Technical Bulletin 6

Model
911 1969-89

Subject: Modifications on
Doors and Hinge Pillars

Concern: Standardization of replacement doors and modification on hinge pillars.

Figure 1

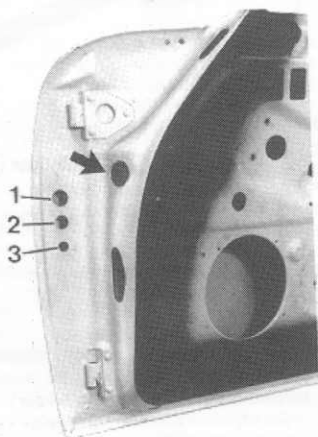
The positions for three wiring harness holes are center punch marked on new doors (figure 1) and must be drilled and deburred as necessary compared to the old door before painting the new door.

- 1 - for electric window lift (20mm diameter)
- 2 - for outside mirror adjustment (16.5mm diameter)
- 3 - for radio speakers (12.5mm diameter)

The hole (arrow in figure 1) must be closed with grommet, part number 999 703 066 50.

Figure 2

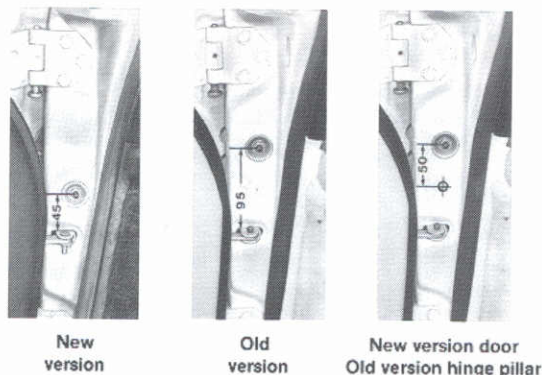
During Model Year 1989, hinge pillars were modified. Hinge pillars remain available in both versions. When installing the new version door on a car with the old version hinge pillar, the door contact switch for the inside light must be positioned 50mm further down.

This requires drilling a new hole, 8.4mm in diameter, 50mm below the old door contact switch hole (figure 2). Deburr edges of the new hole and treat edges with rust prevention paint. Relocate switch into new hole. Install plug, part number 911 531 999 00 in old hole.
